## TECHNICAL SERVICE BULLETIN

### 5.0L - Oil Leaks From Valve Cover Gasket

**19-2309**  
16 October 2019

<b>Ford</b> 2015-2017 Mustang
----------------------------------

Figure 1

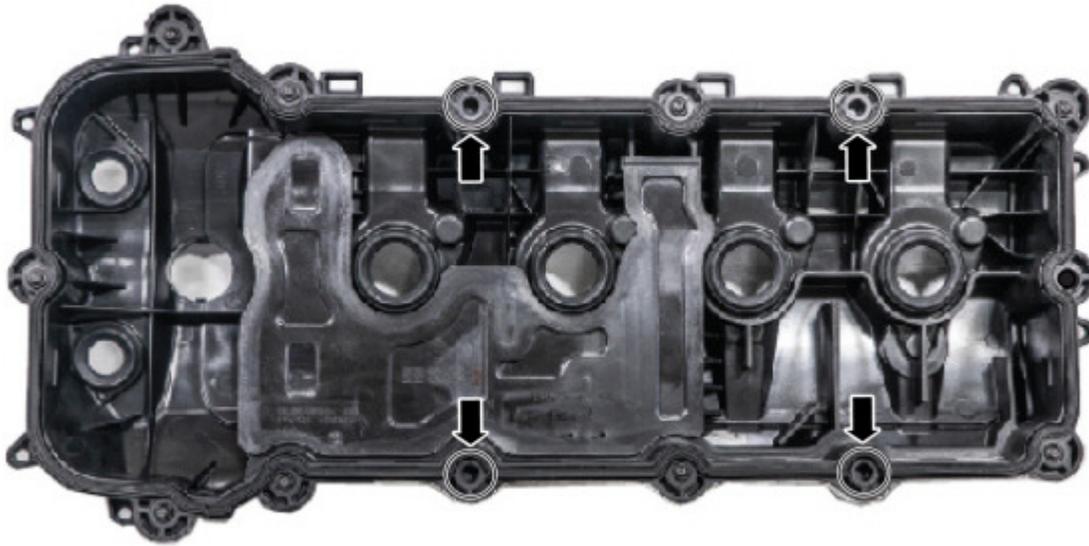
2. Using a 10 mm (0.394 in) drill bit and drilling from the underside of the valve covers, drill holes through the tabs along the perimeter of the valve covers that do not already have holes, skipping over the tabs at the rear center of each valve cover. Following these instructions, each valve cover should require four holes to be drilled. This will allow fasteners to go through these tabs. Use the indented area on each tab as a guide to center the drill bit to make sure the holes are drilled in proper alignment to allow fasteners to pass through them and thread into the corresponding holes in the cylinder head when the valve covers are reinstalled on the engine. (Figure 1, right side shown, left side similar)

Figure 2

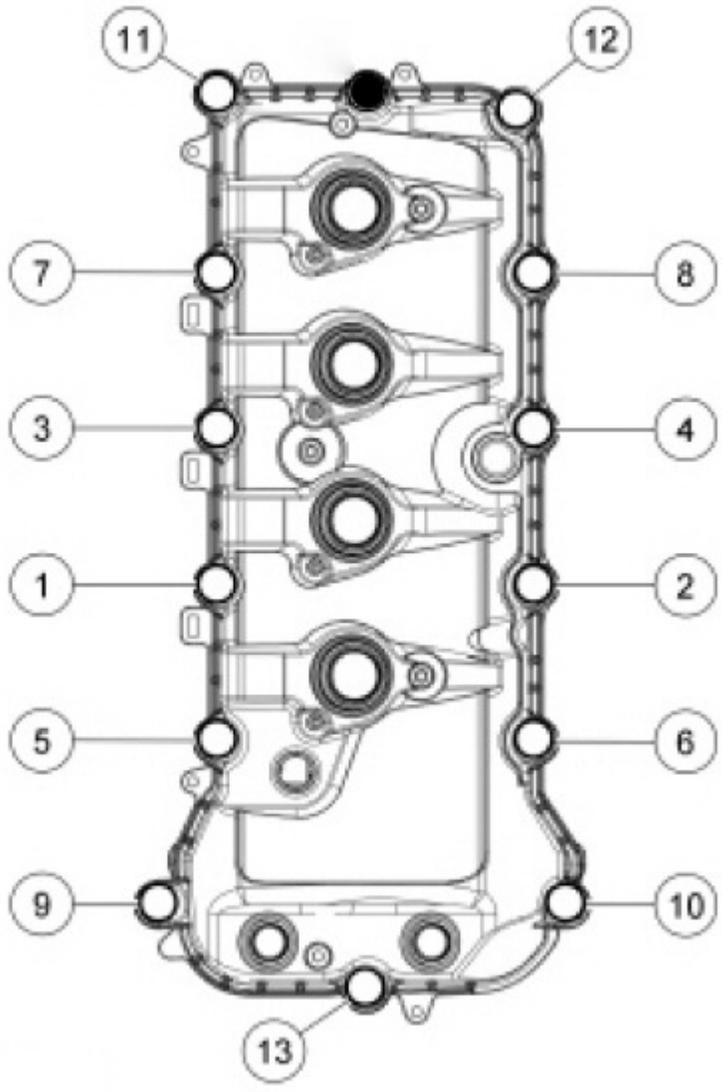
3. Reinstall the valve covers onto the engine, adding fasteners through the holes drilled in Step 2. Refer to WSM, Section 303-01C. Follow the revised tightening sequence in Figure 2 for the left valve cover and Figure 3 for the right valve cover. Tighten the fasteners to 10 Nm (89 lb-in).
